3274/01 Letters Out/2026-03-11

RE: Ffos-y-Fran - Variation of conditions 4 (Duration and Restoration), 6 (Approved Plans) and 50 (Restoration Strategy) of planning permission APP/U6925/A/10/2129921 involving a revision to the restoration scheme.

We refer to a letter dated 05 January 2026 (Ref CAS-295411-Z3C1) from NRW, to Merthyr Tydfil County Borough Council (MTCBC), that was found on the planning portal under application Ref P/25/0037. We set out a response to the letter below as agent acting on behalf of our client Merthyr (South) Wales (MSW).

The location of the two accessible piezometers are shown in the following figure: -

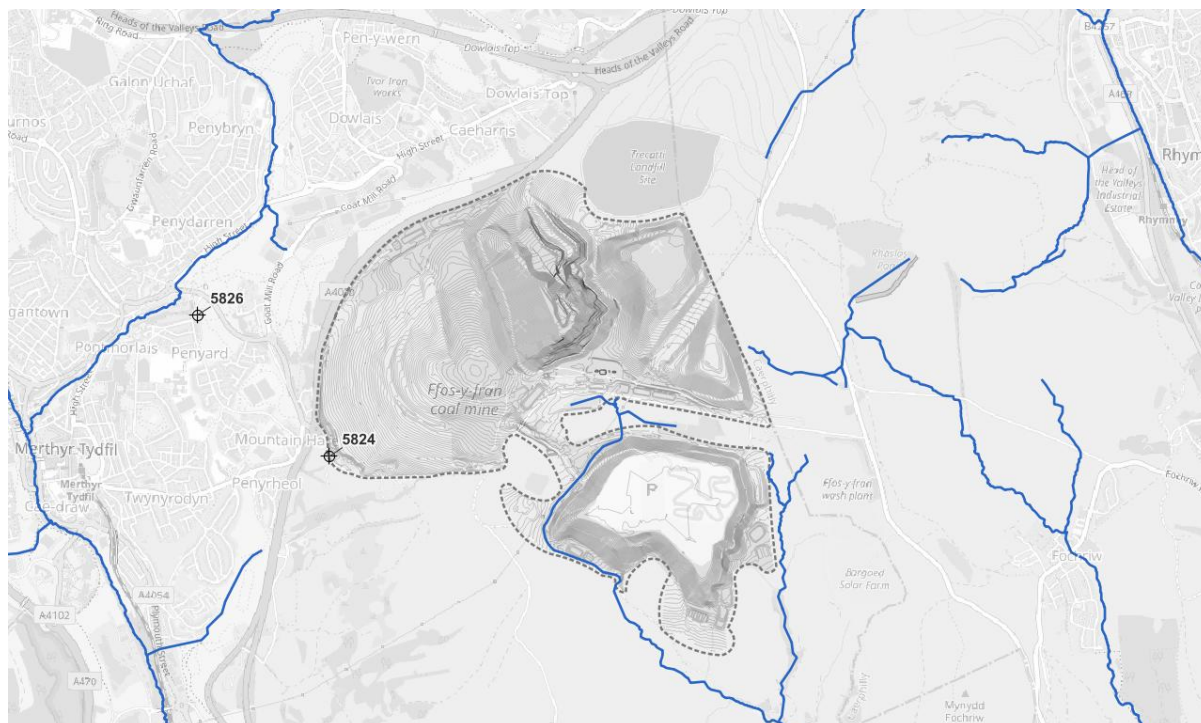
NRW refer to the surface water monitoring plan (SWMP) that provides coverage for surface water only and that there does not appear to be ground water monitoring for groundwater levels. Note is made that borehole BH5824 is monitored for groundwater quality and a request made for confirmation as to whether this is monitored for groundwater level and at what frequency. NRW also advise that a plan showing the monitoring locations should be provided, and whether any other boreholes from around the site could be used to monitor ground water levels.

- BH5824 (Mountain Hare) was installed in May 1996 and monitored for groundwater levels and water quality during the operational period of the mine until July 2023. The borehole was not monitored again for depth again until September 2025 to inform the EIA process. MSW last dipped the borehole on 25th February 2026 and will continue to dip every two weeks until the end of 2026 after which monitoring will be reviewed and continued on a monthly or quarterly basis until the end of 2027. Monitoring beyond 2027 would need to be reviewed and agreed with NRW/MTCBC but is suggested quarterly or biannually with a final review after 5 years. Timings are dependent on the date of a planning application being approved and discharge of any conditions.

- MSW have now checked if there are any other boreholes remaining in an operable condition for ground water monitoring and confirm that BH5826 is still accessible. This piezometer is located to the west of the site, as shown on Figure 21 (page 70) of the Hydrogeology Technical Report (ES Volume 3, Appendix 8A). This borehole was installed in May 1996 and was also dipped throughout the operational period of the mine until July 2023. It was not dipped again until 25th February 2026 when the level recorded was consistent with historical measurements. It is proposed to continue to dip this borehole as per BH5824 going forward.
